From: [REDACTED]
Sent: 20 June 2024 21:15
To: Hamish Evans
Cc: Kevin Toogood
Subject: Comments on Application DM/23/2493

I would like to submit the following comments on planning application DM/23/2493. In particular to discuss some points made in Yes Engineering's rebuttal letter of 5th June, because for the first time Yes Engineering have conceded that their Figure 3.1 does not show visibility lines drawn in accordance with DMRB.

Figure 3.9 Additional area of visibility on the outside of a curved major road

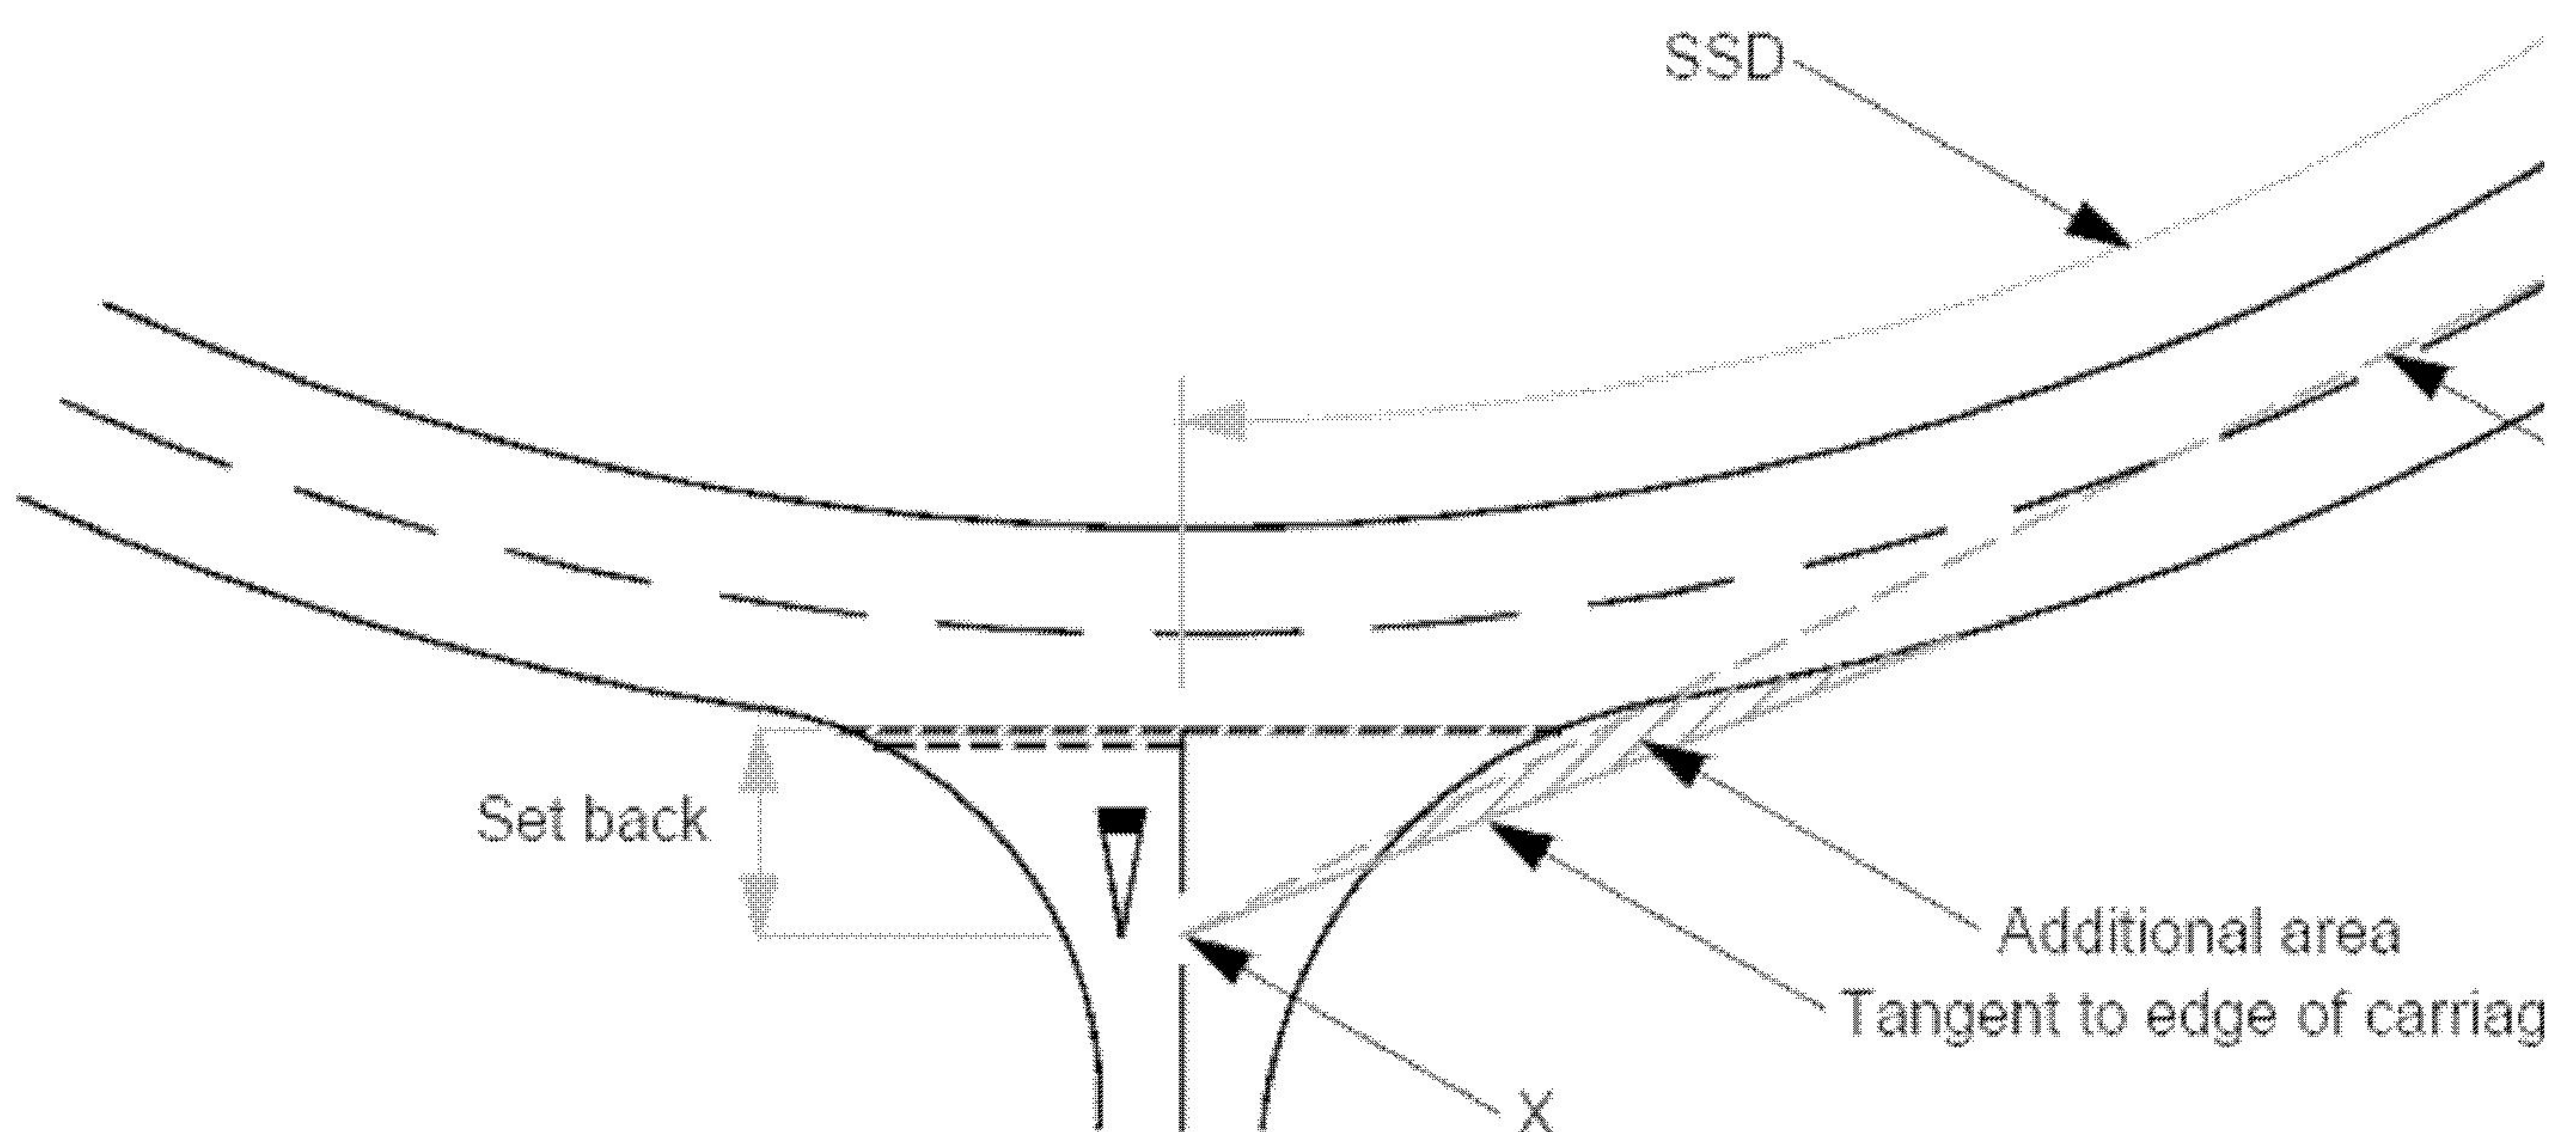
Clearly, in the narrative in item 2. Paul Willis accepts that Yes Engineering did not draw the visibility line to the tangent as required by DMRB CD123 V2.1.0 Section 3.9, and he gave as one of the reasons for not doing so as *'it is extremely difficult to ascertain the exact position of the tangent point due to the lack of defined carriageway'* (strangely no such difficulty arose during the topological survey in surveying the whole road which Yes Engineering claim as best practice). In fact no attempt whatever was made to comply with Section 3.9 as Yes Engineering drew the line halfway across the carriageway at the point where it should have been tangential and claimed that was acceptable as motorcycles don't ride at the edge of the carriageway.

So in summary, Yes Engineering have chosen to ignore a whole section of DMRB standards and claimed that there is flexibility to do this *'when all factors are considered'*. But what are the factors in this case? Why would a sub-optimal solution be acceptable in this case? There is no physical impediment to fully complying with DMRB. The answer is simply that Yes Engineering do not wish to admit that a DMRB compliant solution, therefore the optimal safety solution, requires the use of third party land. The impediment isn't physical, it is legal.

Clearly, Yes Engineering propose that WSCC and the LPA should accept their recommendation, compromise road safety by not adhering to DMRB standards for the simple reason that their client wants to avoid a visibility splay agreement with a neighbour. This should of course be resisted. As it was previously.

3.9 Where the line between points X and Y falls partially within the major road carriageway, an additional area shall be added to the visibility splay formed by drawing a line from X to a point tangential to the nearer edge of the major road running carriageway, as illustrated in Figure 3.9.
